Access Compliance Report

Public Rights-of-Way

Intersection ID: 16413	Main Street: LANIER_AV	Cross Street: MONROE_RD	Location: NW
ADA ID: 0C527818ED71	Ramp Type: ParaDiag	Initial Pass/Fail: Fail	Overall Compliance: No
			Severity Score: 21.25

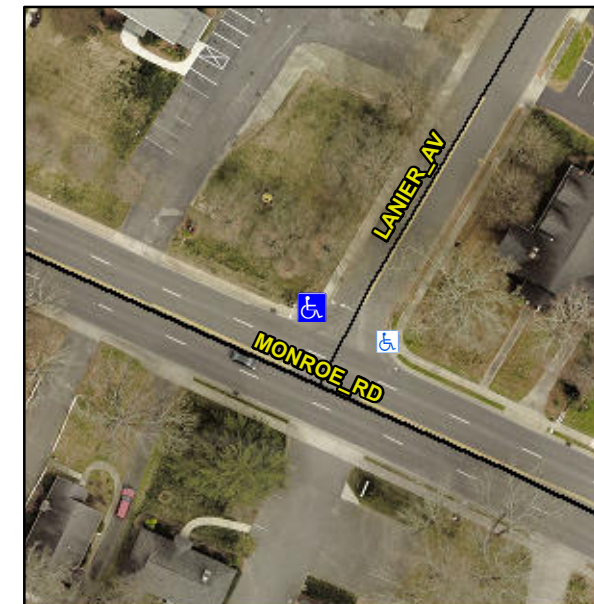
R304.5.1, R304.3.2

Compliance	Description	Data	Compliance	Description	Data
N/A	Ramp Length LT (in)	87.0	N/A	Ramp Length RT (in)	80.0
No	Ramp Width LT (in)	42.0	Yes	Ramp Width RT (in)	48.0
No	Ramp Slope LT (%)	8.7	Yes	Ramp Slope RT (%)	8.1
Yes	Ramp XSlope LT (%)	1.2	Yes	Ramp XSlope RT (%)	0.9
N/A	Landing Length (in)	N/A	N/A	DWS Provided?	N/A
N/A	Landing Width (in)	N/A	N/A	DWS Contrast?	N/A
N/A	Landing Slope (%)	N/A	N/A	DWS Length (in)	N/A
N/A	Landing X Slope (%)	N/A	N/A	DWS Full Width?	N/A
N/A	Landing Curb? (Y/N)	N/A	N/A	DWS Offset (in)	N/A
N/A	Shared Landing?	N/A			
N/A	Gutter Ponding?	N/A	N/A	Gutter Slope (%)	N/A
N/A	Gutter Lip Ht (in)	N/A	N/A	Gutter X Slope (%)	N/A
N/A	Painted X Walk1?	No	N/A	Painted X Walk2?	No
	X Walk 1 Direction	To SW		X Walk 2 Direction	To SE
N/A	X Walk 1 Width (in)	N/A	N/A	X Walk 2 Width (in)	N/A
	X Walk 1 Slope (%)	1.0		X Walk 2 Slope (%)	0.2
	X Walk 1 X Slope (%)	0.3		X Walk 2 X Slope (%)	0.1
N/A	Ramp inside XWalk1?	N/A	N/A	Ramp inside XWalk2?	N/A

Road Slope (%)	0.8	N/A	Clear Space?	N/A
	Road X Slope (%)	2.0	N/A	Clear Space to XWalk (in)	N/A
N/A	Any Obstructions?	N/A	N/A	Storm Grate/Utility Hazard?	N/A
	Obstruction Type			Storm Grate/Utility Type	
		N/A			N/A
			Yes	Surface Condition? (G/P)	Good
			N/A	Curb Slope (%)	9.0

Remove & Replace Curb Ramp With Two New Directional Ramps or Equivalent.
